BWVRVIP-41NP, Revision 4-A: BWR Vessel and Internals Project

BWR Jet Pump Assembly Inspection and Flaw Evaluation Guidelines

Final Report, December 2018

Figure 4A: Plan View of Typical BWR Reactor
(excerpted from BWRVIP-281NP, Figure 3-2)

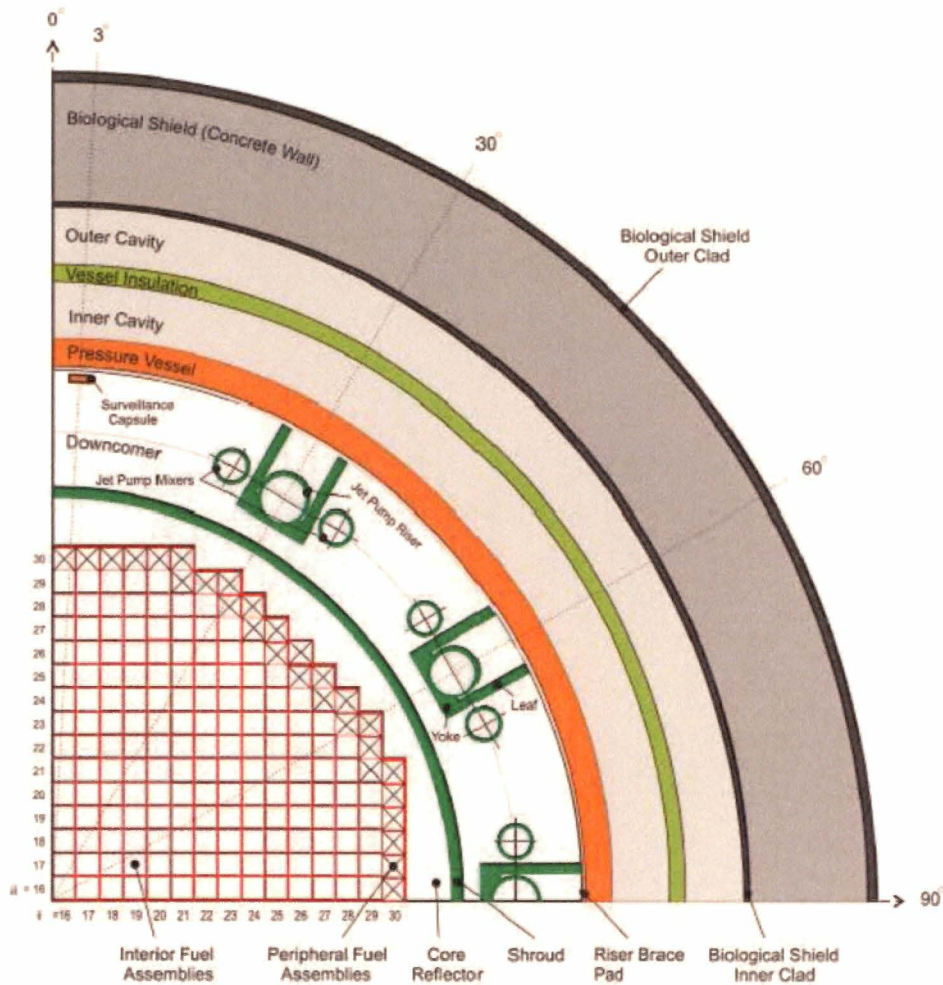
As anticipated, differences in plant design were found to result in significant variations in jet pump EOL fluence. Design factors affecting EOL fluence estimates include, but are not limited to, reactor size, number of fuel bundles / fuel arrangement, power uprate status, and the size of the annulus region. Further, within a single plant, some jet pumps are subject to higher fluence than others as a result of azimuthal location. Since the fuel bundles are rectangular, the distance from the edge of the core to the jet pump varies somewhat, resulting in different EOL fluence estimates. Figure 4A provides a plan view

Figure 4B: Elevation View of Typical Jet Pump Assembly
(excerpted from BWRVIP-281NP, Figure 3-3)

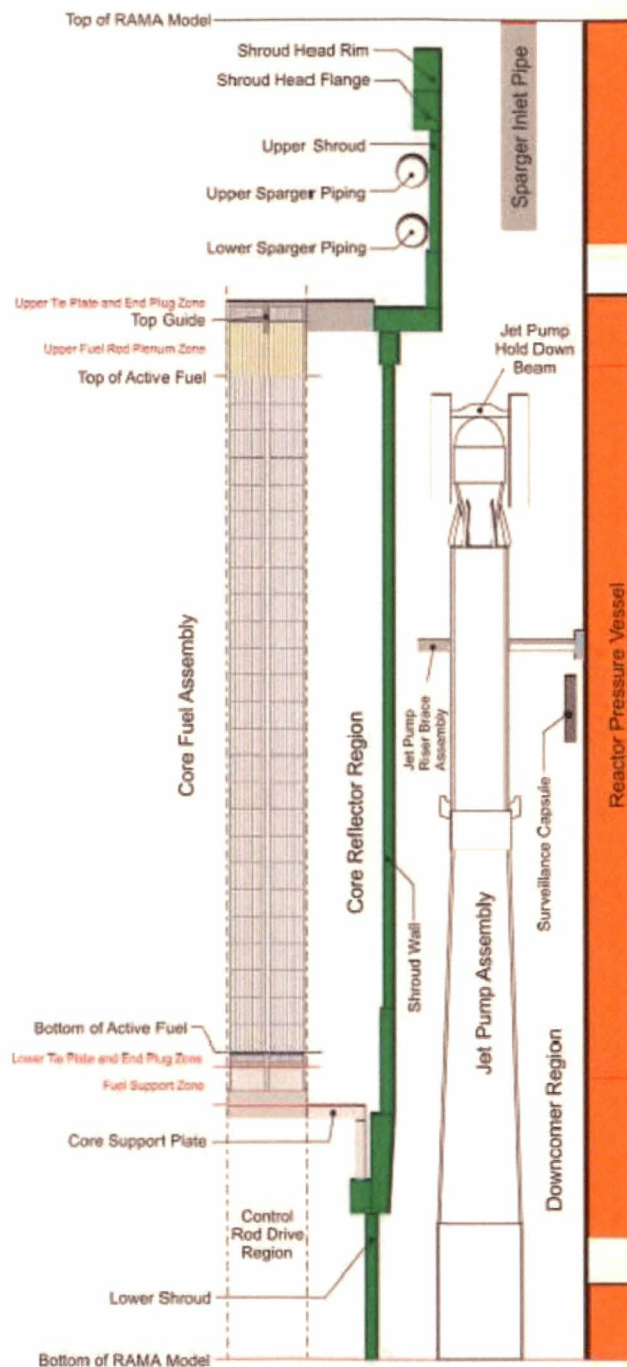
Finally, within a single jet pump assembly, the estimated EOL fluence for individual weld locations varies substantially as a function of elevation. The lower end of the jet pump assembly is located well below the core plate, in a region of low fluence. Jet pump locations higher in elevation are exposed to progressively increasing neutron flux, with a substantial increase in fluence occurring for components located within the height of active fuel. Figure 4B provides a typical jet pump assembly elevation view in relation to the core.
